**Toowoomba Regional
Council**

**Report for Cooby Dam
Special Dam Safety Inspection
following January 2011 Flood**

Rev 1 – February 2011

Photo 38 Undermined section of stairs and fence at downstream end of spillway

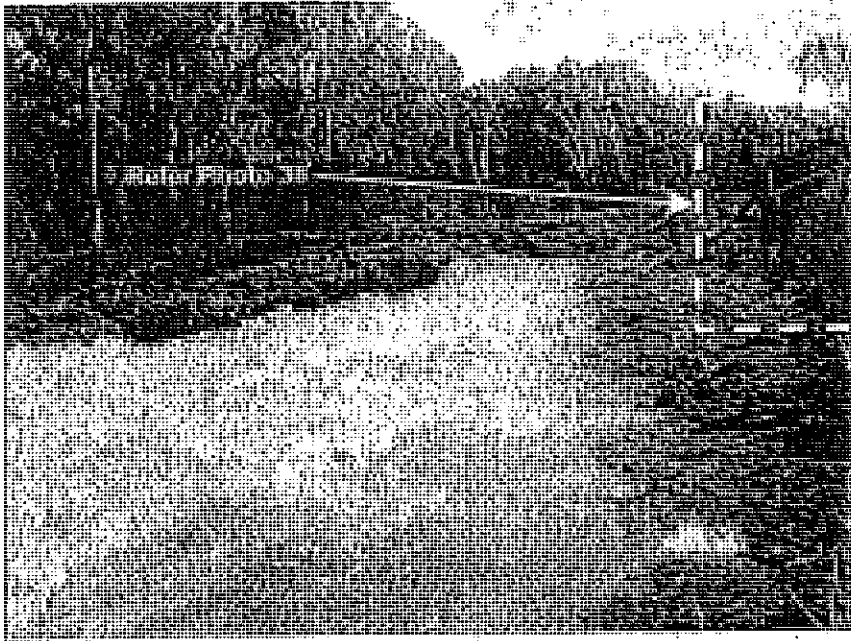
General condition	Not inspected in detail.
Erosion	Undermining of the left side cut towards the downstream end was observed, in particular in the vicinity of the bottom of the stairs (Photo 36 and Photo 38).
Debris	
Loose rocks	
Vegetation

- ▶ ***R6.4.1/11-S – Prevent public access to top of the left side spillway cut between the weather station and the downstream end of the spillway due to undermining of the cut slopes.***
